Work Order ID 96983

Item Name: Crosstube Turning Detail

DART AEROSPACE LTD	Work Order:	96983
Description: Crosstube Assembly	Part Number:	D407-667-145
Inspection Dwg: D407-667-145 Rev: C		Page 1 of 2

DRAWING NO. D407-667-145	TITLE CROSSTUBE ASS'Y (407 HIGH FWD)	REV. C	DART AEROSPACE LTD ENGINEERING ORDER		D.E.O. NO. D407-667-145-C-1	SHEET NO. SHEET 1 OF 1	SCALE NTS
DRAWN 92	CHECKED ASS	MFG. APPR. 182	APPROVED WD		DE APPR. H		
DATE 11.07.15	DATE 11.07.22	DATE 11.07.22	DATE 11/07/22		DATE 11.07.21

**DETAIL P**
BONDING STRAP INSTALLATION 2 PL

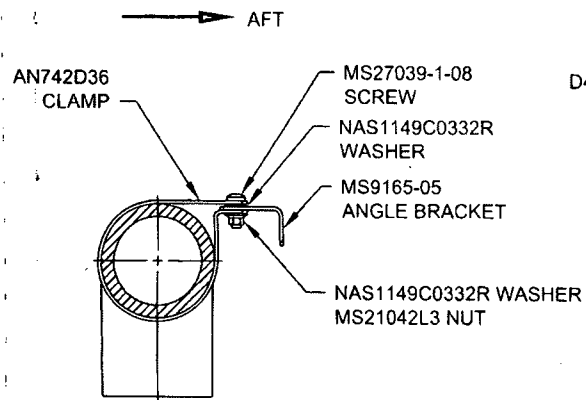
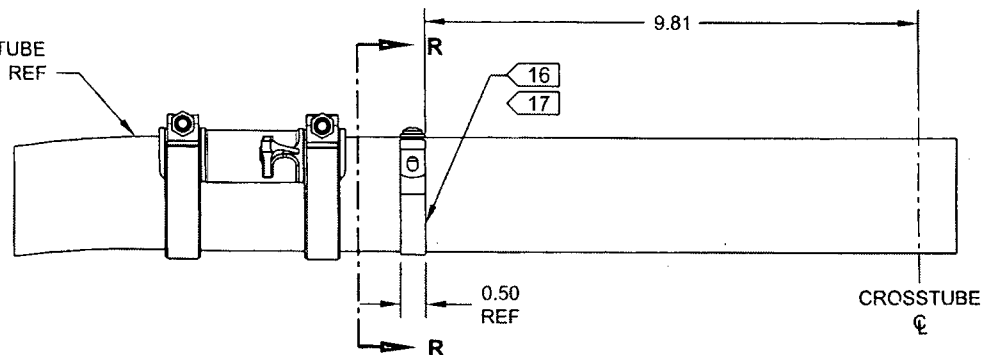
ADD ELECTRICAL GROUNDING STRAP

ITEM	QTY -145	PART NUMBER	DESCRIPTION
1	X	D407-667-145	CROSSTUBE ASSEMBLY (407 HIGH FWD)
10	2	AN742D36	CLAMP
11	2	MS9165-05	ANGLE BRACKET
12	2	MS21042L3	NUT (OR MS21042-3)
13	2	MS27039-1-08	SCREW
14	4	NAS1149C0332R	WASHER (OR AN960C10L)

- 16) MASK AREA UNDER CLAMP PRIOR TO PAINTING
 17) SEAL EDGES WHERE AN742D36 CLAMP MEETS WITH THE CROSSTUBE USING SIKAFLEX-241/-291 OR MIL-S-8802 CLASS B2 OR PROSEAL 890 SEALANT
 18) PERFORM RESISTANCE CHECK TO ENSURE MAX RESISTANCE IS 10 MILLIOHMS
